Overall assessment: Falls far short of goals and expectations

The proposed concepts to address pedestrian safety on this segment of MD 214 are greatly disappointing and fall far short of meeting project goals. The overarching problem with this roadway -- high vehicle speeds are largely generated by an overly wide 6-lane cross section, which is excessive for the traffic volumes. A 6 to 4-lane conversion, especially where traffic volumes are lower - close to Southern Avenue, could manage traffic volumes while addressing severe safety concerns along this corridor. An interim measure could be to permit on-street parking during off-peak hours.

Pictured: On-street parking on East Capitol Street, DC, off-peak (parked vehicles circled)

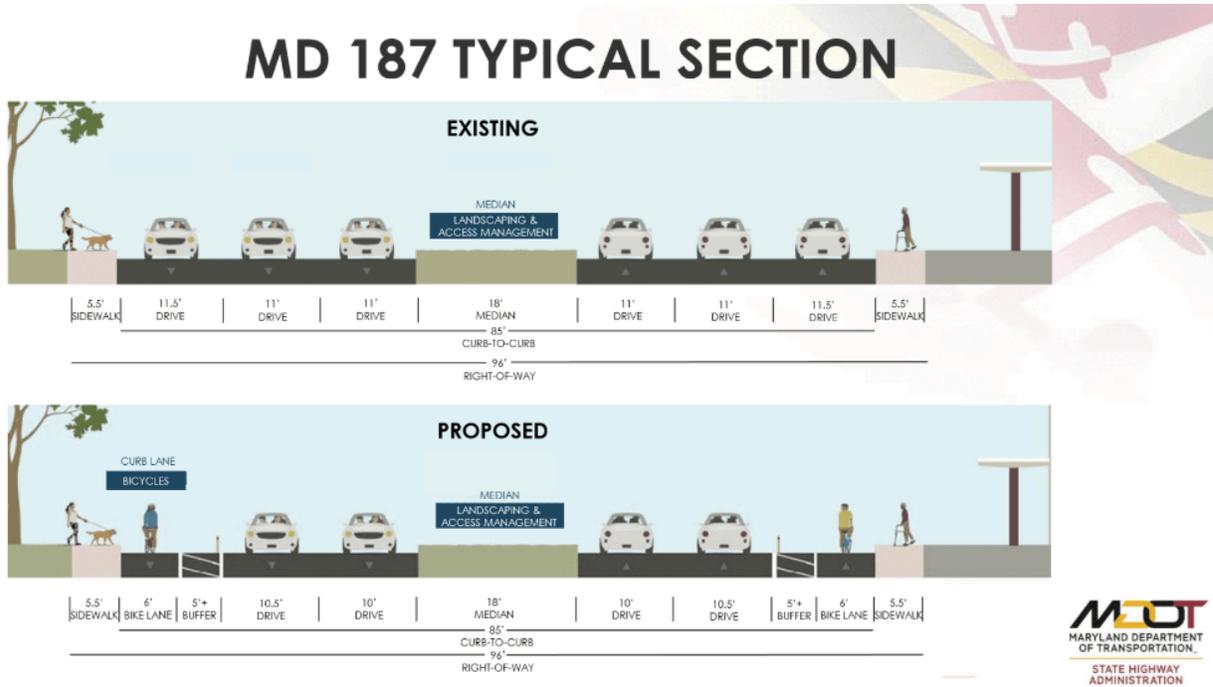
- **6-to 4-lane conversion:** A 6-lane to 4-lane conversion, recommended in the draft [Central Ave.-Blue/Silver Line Sector Plan](#) and [Go Prince George's](#), should be a top priority for the safety plan, especially near Southern Avenue where traffic volumes are lowest and the roadway narrows going into DC. Few interventions will slow traffic or make it safer or easier to walk across the wide cross section if the 6 travel lanes are retained.
- **On-street parking during off-peak periods:** An interim measure that would narrow the travelway off peak would be to permit on-street parking. This would be consistent with the roadway's treatment in the District of Columbia (see photo below).

This off-peak parking could be metered for Metro riders where parking demand will be strong around the Capitol Heights and Addison Road-Seat Pleasant Metro stations. While pedestrian movements around parked cars still need to be addressed with on-street parking, parked cars reduce the width of the travelway and lower driving speeds.
